Hamsland, Horsted Keynes St Stephen's Church, Land to the South of

Land ownership and highway configuration at proposed site entrance

- This document reviews Rydon/RPS's updated Proposed Site Access, Visibility Splay drawing 1044-FA-203 Rev C which Rydon has submitted as Action Note 11, Appendix 5 (Ref: REP-2140-002e)

Rydon earlier Rev B access proposals

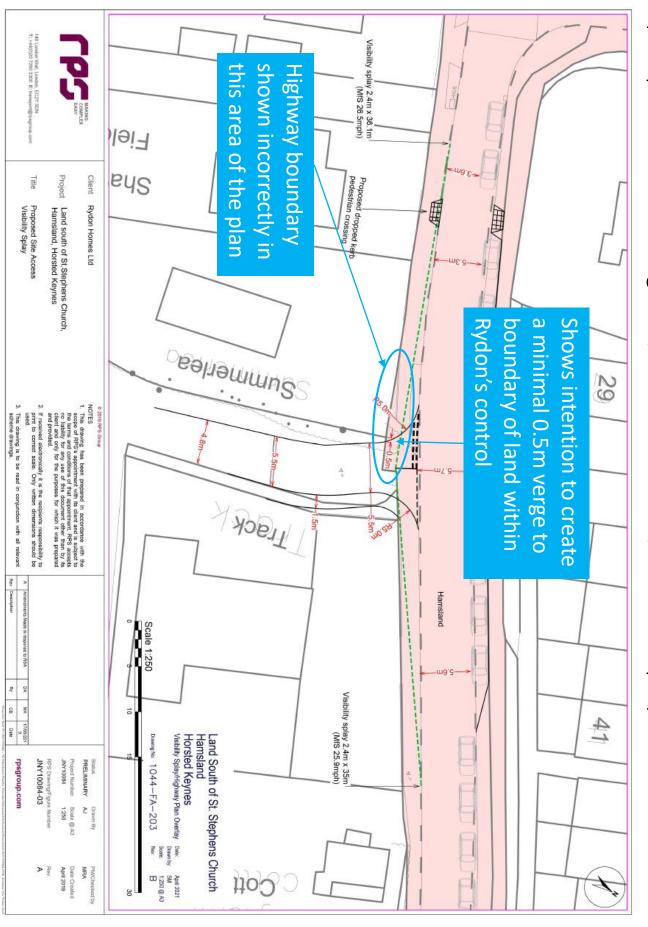
- Rev C (Action Note 11, Appendix 5) makes minor modifications to the access and introduces a critical additional line which appears to confirm that the site access needs additional land beyond that in Rydon's control.

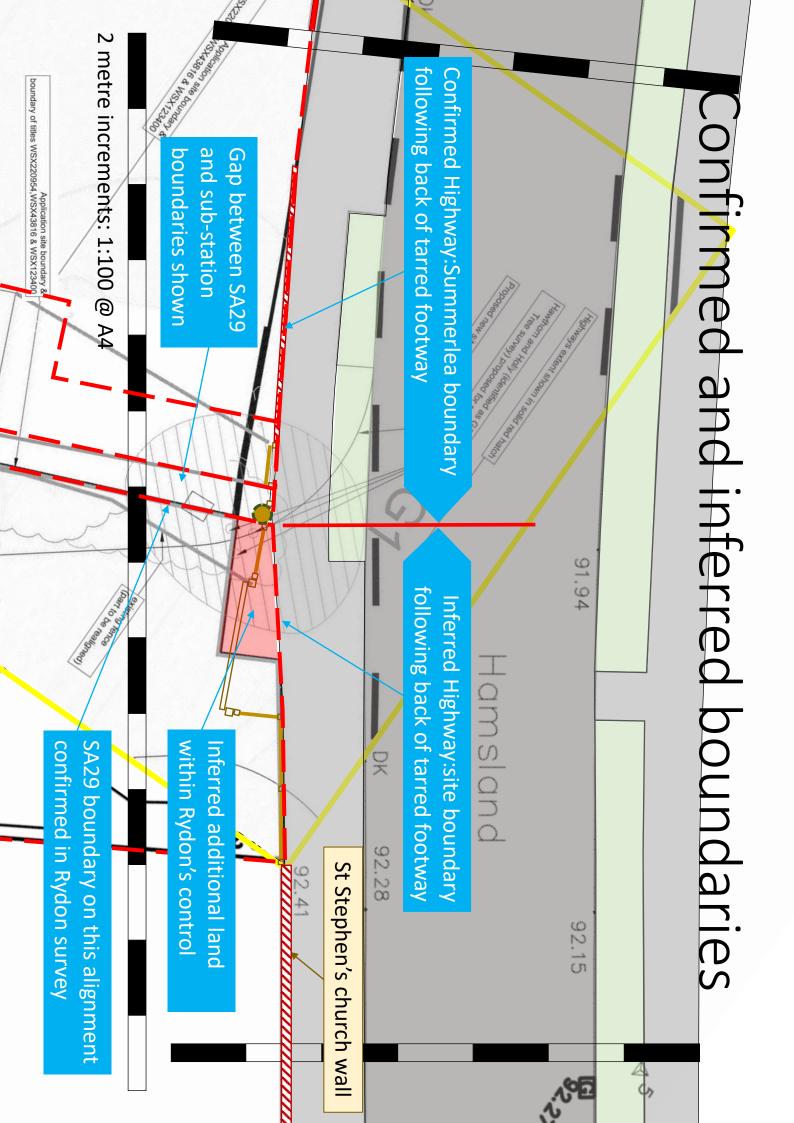
clashes with parked cars by up to c.0.5m 2 metre increments: 1:100 @ A4 and parked vans by up to c.0.9m 5.7m zone for refuse vehicle swept path Application site boundary boundary of titles WSX220954,WSX43816 & WSX1294 Rev Baccess proposals assessed 0.5m wide verge extends into beyond / on site boundary land beyond site boundary and removes holly tree 91.94 m_{V.}2 5.5m lay-by zone 2.0m wide 1.5m wide footpath width Stephen's Church wal restricted by end of St SA29 boundary on this alignment confirmed in Rydon survey 92.2 St Stephen's church wall

by up to c.0.5m and parked vans by up to c.0.9m vehicle swept path appears to clash parked cars tangential with kerb. 5.7m zone for refuse Traffic Signs Manual requires Give Way line to be

boundary and removes holly tree beyond / on site boundary ហ្វៀ 1.0m wide verge extends further into land beyond site

and to provide visibility for pedestrians by Rydon in Rev C to make the access work Up to 1m wide triangle of land now claimed

to make the access work Land relied on by Rydon beyond its control

> moved south-west which restriction on footpath Bellmouth has been has reduced width

shown too far to the north inaccurately, so lay-by

showing verge extending 1.0m New line on Rev C drawing beyond SA29 site boundary

Rydon updated Rev C access proposals

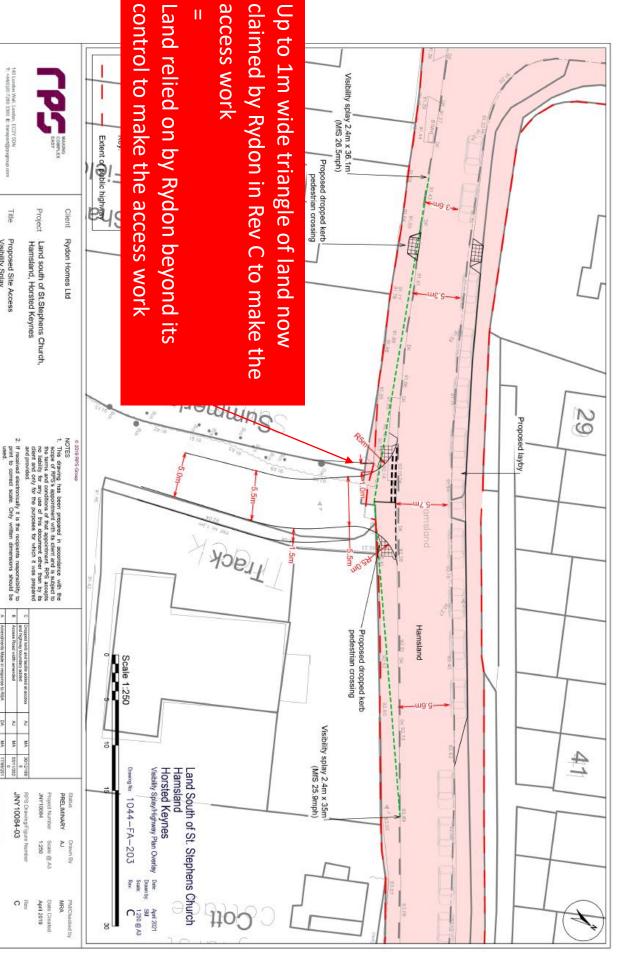
- This analysis has been drawn carefully to scale using Rydon's survey as a base to correct drafting errors evident in Drawing 1044-FA-203 Rev C. It demonstrates conclusively that Rydon:

- Can just provide acceptable visibility splays within the highway and/or on land in its control, albeit this may require X to be reduced to from 2.4m to 2.0m to avoid St Stephen's church land; but

- <u>Cannot</u> accommodate the bellmouth access, with a footpath to the east and a verge to the west, within the highway and/or on land in its control; and

- <u>Cannot</u> provide for the safe swept path of refuse vehicles entering and leaving the site without losing essential parking on Hamsland;
- a c.1m wide verge with adequate visibility for pedestrians within its control, in order to provide the bellmouth access and heightened concern that Rydon does not have control of the Each successive Revision of Drawing 1044-FA-203 has necessary land. In Revision C, Rydon appears to confirm this by introducing a claim tor a triangle of land that is not currently
